DEVELOPMENT ASSESSMENT PANEL REPORT	
<b>Application No.</b>	DA/2024/0620
<b>Address</b>	56 Ballast Point Road BIRCHGROVE
<b>Proposal</b>	Alterations and additions to an existing semi-detached dwelling, including partial demolition of existing structures. Works include internal reconfiguration, convert the existing first floor verandah into a winter garden, new kitchenette on the second floor roof top terrace, two new air conditioning units on the south western corner of the roof top terrace, altered curved roof structure to roof terrace and new fence fronting Bates Street.
<b>Date of Lodgement</b>	26 July 2024
<b>Applicant</b>	Adam Byrnes
<b>Owner</b>	Gisoan Pty Ltd
<b>Number of Submissions</b>	Initial: 4
<b>Cost of works</b>	\$475,530.00
<b>Reason for determination at Planning Panel</b>	Section 4.6 variation exceeds 10% Heritage Item
<b>Main Issues</b>	Bulk and scale Matters raised in submissions

<b>Recommendation</b>	Approved with Conditions
<b>Attachment A</b>	Recommended conditions of consent
<b>Attachment B</b>	Plans of proposed development
<b>Attachment C</b>	Section 4.6 Exception to Development Standards
<b>Attachment D</b>	Statement of Heritage Significance

Image 4: Proposed roof terrace design (NTS)

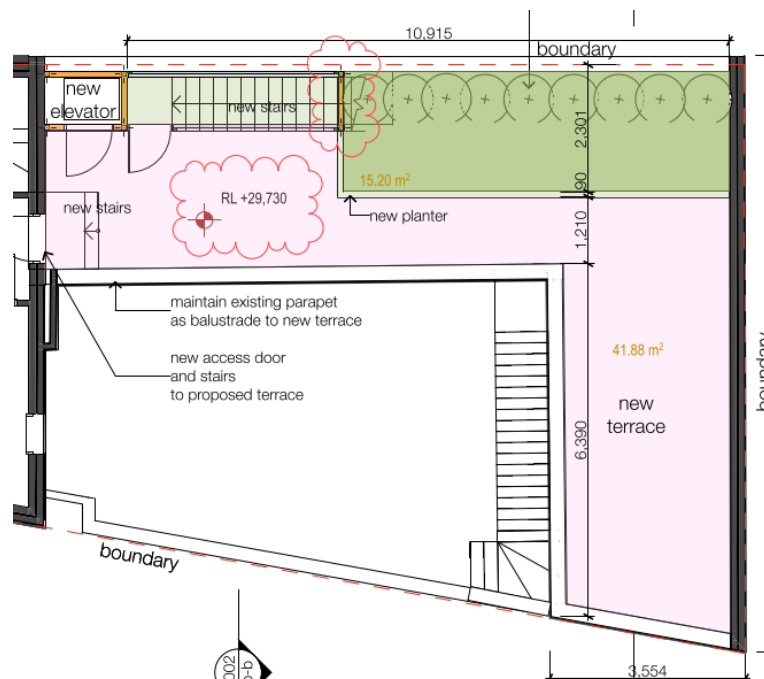
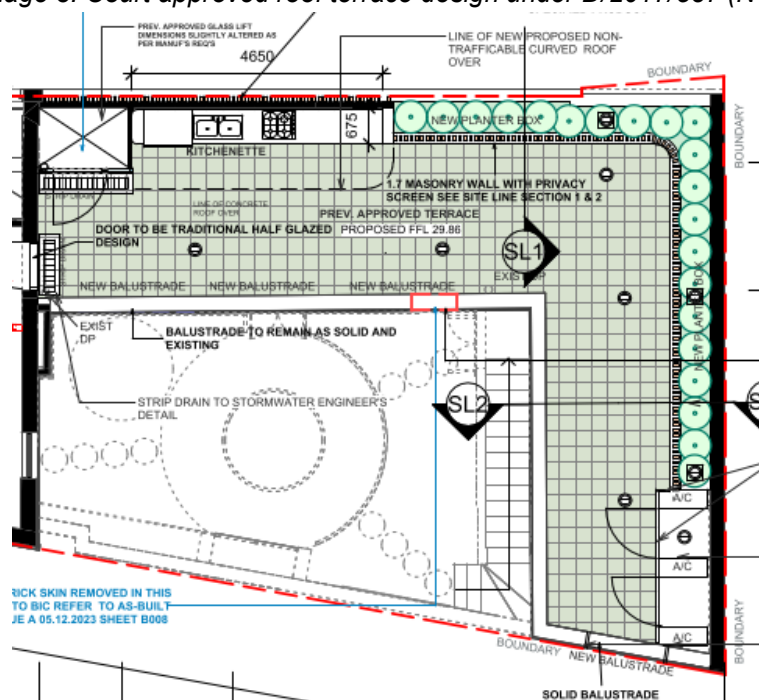
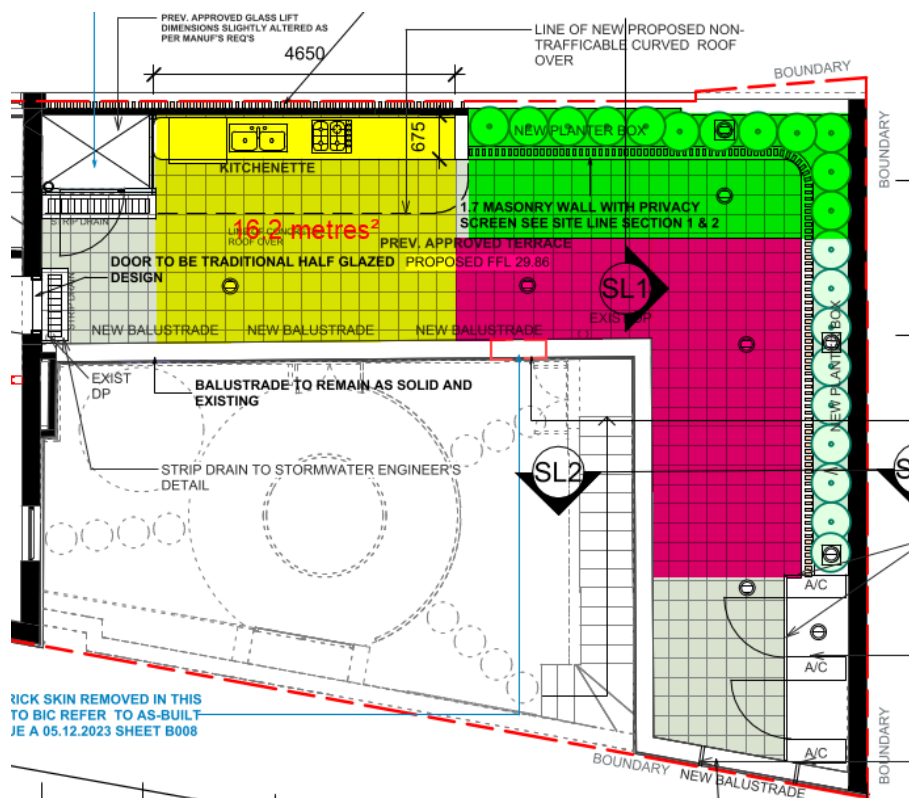
To mitigate these impacts, the planter bed along the south eastern elevation should be conditioned to be increased to a depth of 2m, measured from the inner edge of the south eastern boundary wall. This design change will provide greater separation between the trafficable area of terrace and No. 56 Ballast Point Road. With these changes, the proposed POS will also continue to meet Control C1 (b) requirements (minimum area of 16sqm and dimension of 3m), providing a functional and usable space for residents while minimising visual and acoustic privacy impacts on neighbouring properties.
